LARAMIE COUNTY PLANNING & DEVELOPMENT DEPARTMENT

TITLE: PUBLIC HEARING regarding a Subdivision Permit and Plat for J BAR L Subdivision, for a portion of the NW1/4 SE1/4 Section 24, T.15N., R.65W., of the 6th P.M., Laramie County, WY..

PZ-21-00058(59)

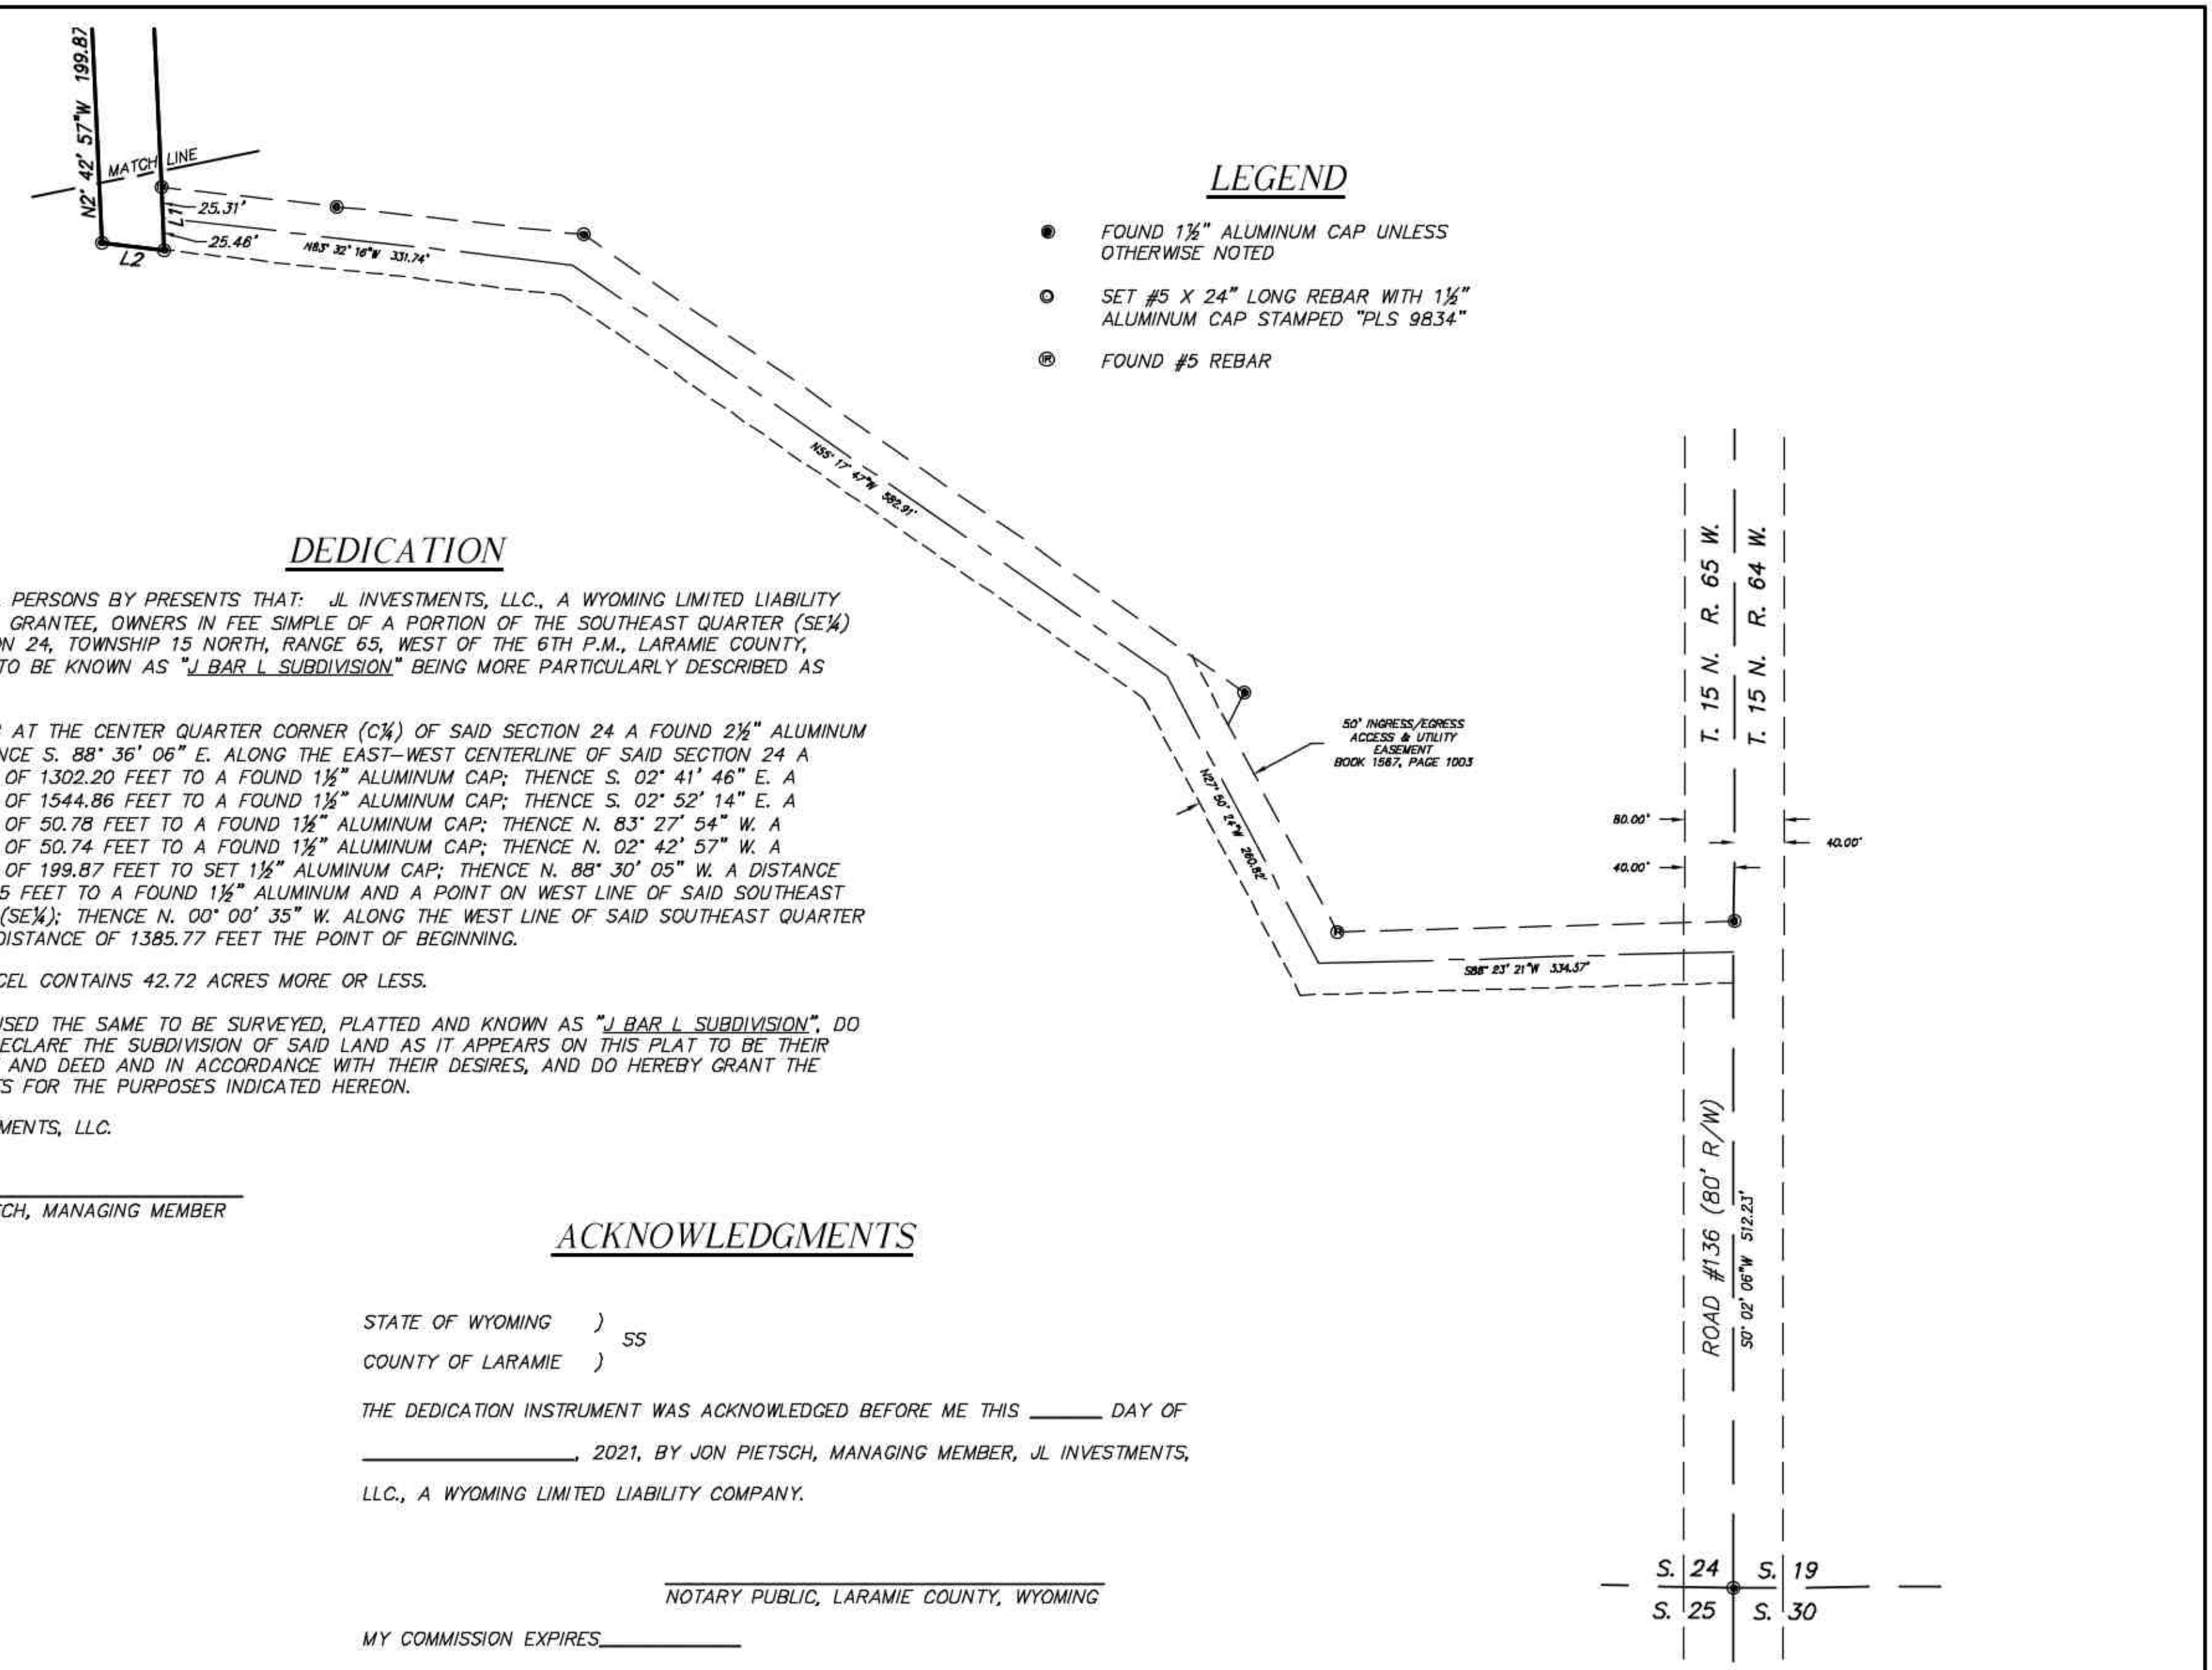
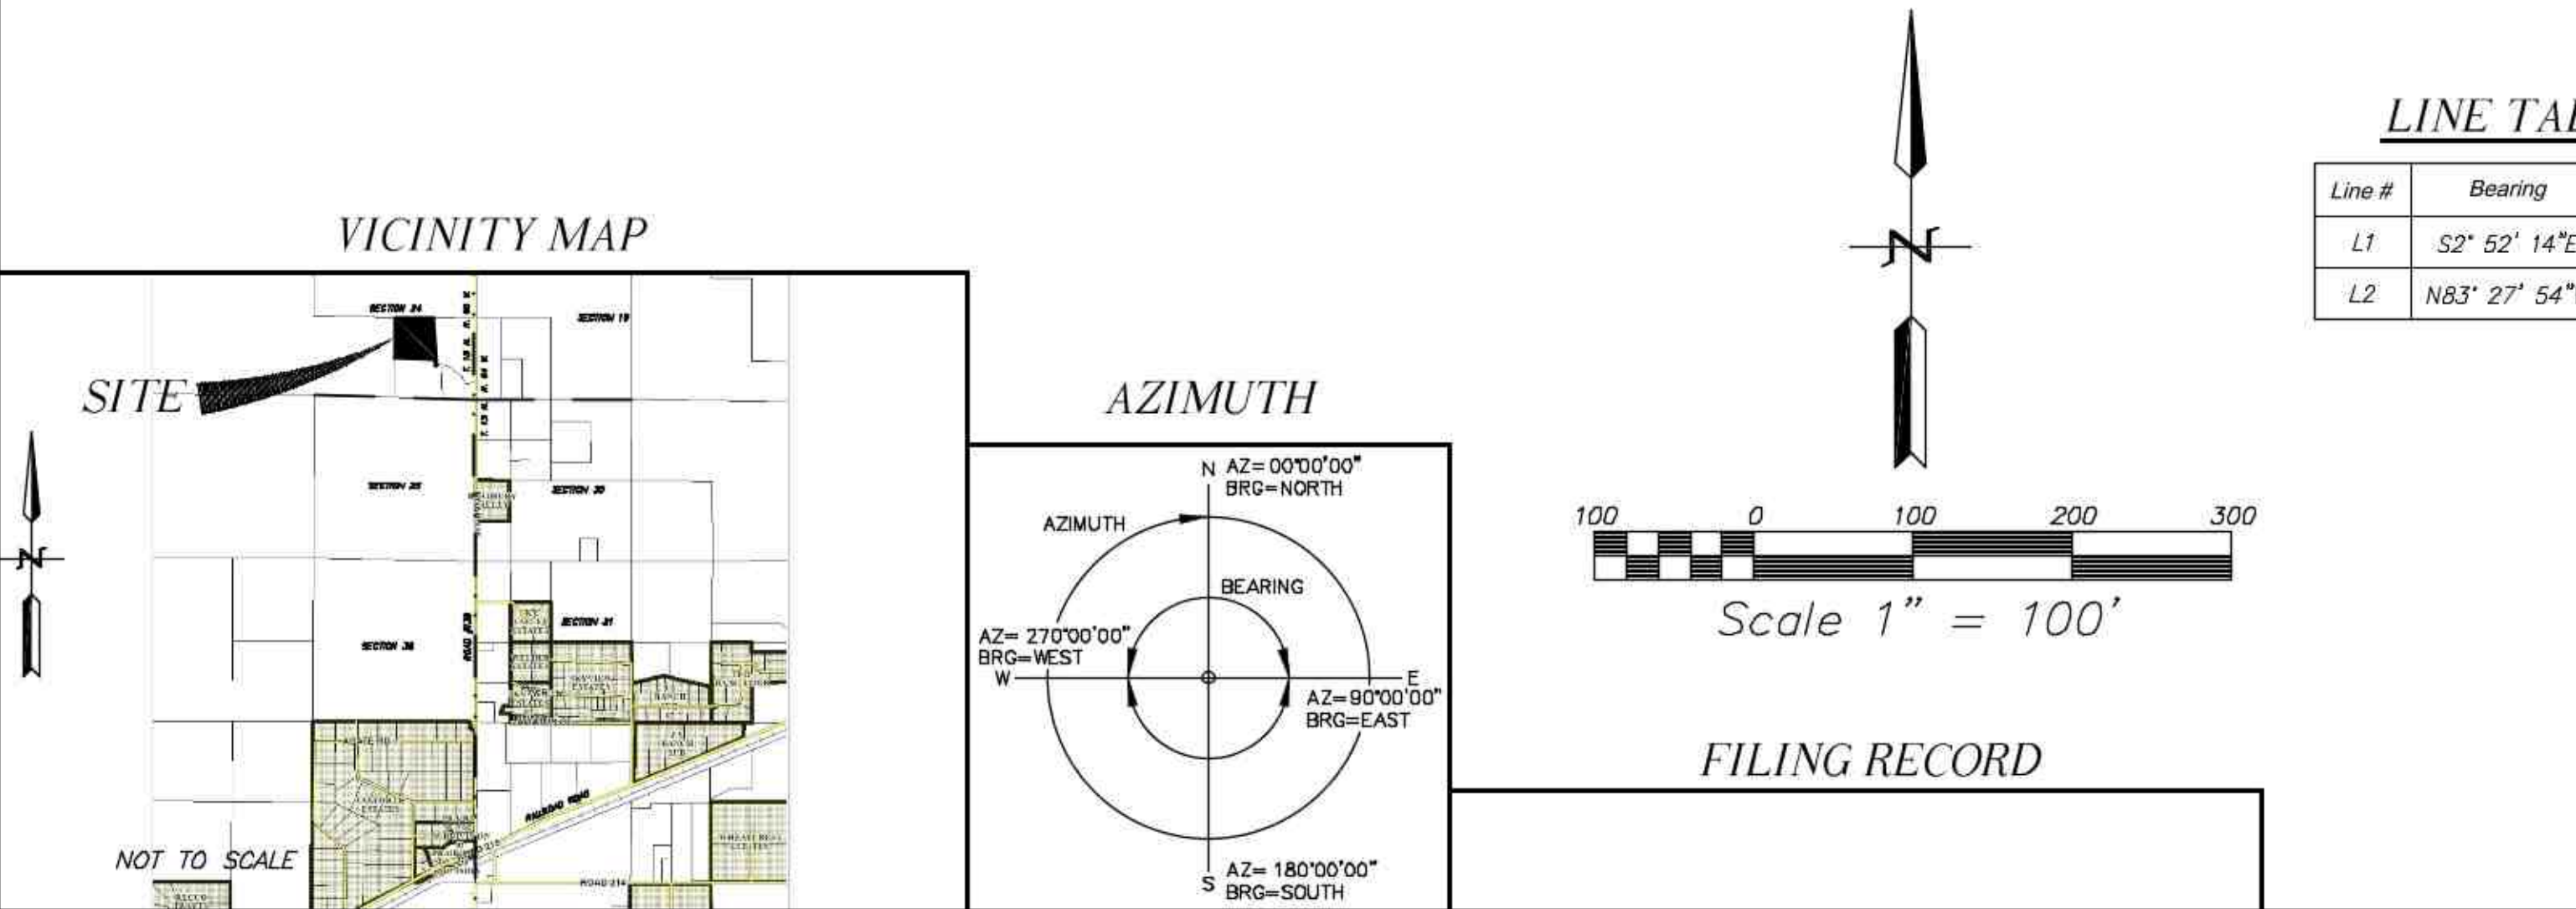
County Assessor: County Assessor, Kaycee Eisele Comments Attached 03/10/2021
APPROVALS AREA, DATE IS STILL MARKED 2020.

County Attorney: County Attorney, Joe Chenchar Comments Attached 03/23/2021
Our office has concerns regarding the access to the property. First, the easement does not clearly identify a dominant estate owner. Second, it is unclear whether the easement effectively transferred to the current owner, or if it will transfer given the proposed subdivision of land. Third, the expected increase in daily traffic has the potential to increase the burden on the servient land.

County Engineer: County Engineer, Scott Larson Comments Attached 03/23/2021
PZ-21-00059 -- J BAR L Subdivision -- Subdivision Permit/Plat Review
Engineer Review

1. The year listed under the Approvals are both shown as 2020 which should actually be 2021.
2. I concur with the request for a waiver of a detailed Traffic Study and Drainage Study since this development will have a negligible impact on both.
3. The roadway from CR136 to the end of the cul-de-sac shall be designed and constructed to meet the current LCLUR. The designs shall be submitted to the County for review and approval.

1. The exact location and specifications for the 50' radius curve of the INGRESS/EGRESS ACCESS EASEMENT located in the southwest corner of Tract 1 and the exact location and specifications for the CUL-DE-SAC located at the north end of the INGRESS/EGRESS ACCESS EASEMENT are not completely identified as specified in this section of the regulations.
2. With respect to the 50' INGRESS/ACCESS & UTILITY EASEMENT shown as recorded in Book 1587 on Page 1003, it would be good to include the survey tie to the Southeast Corner of Section 24.
3. Should the 50' INGRESS/EGRESS ACCESS EASEMENTS have road names?
4. Some of the text is pretty small and difficult to read.

1. Are the tract acreages net or gross? I assume they're net due to Note 4, but it is not clear.
2. The vicinity map is not legible.
3. Approval dates must be updated to 2021.
4. See Engineer/Surveyor's comments regarding missing cul-de-sac and radius details. These, along with a curve table, must be shown on the plat per 2-1-101 (e)(xiii)(b).
5. County Road 136 needs to be labeled as just Road 136.

REV. 04/28/21
REV. 04/16/21
REV. 03/25/21
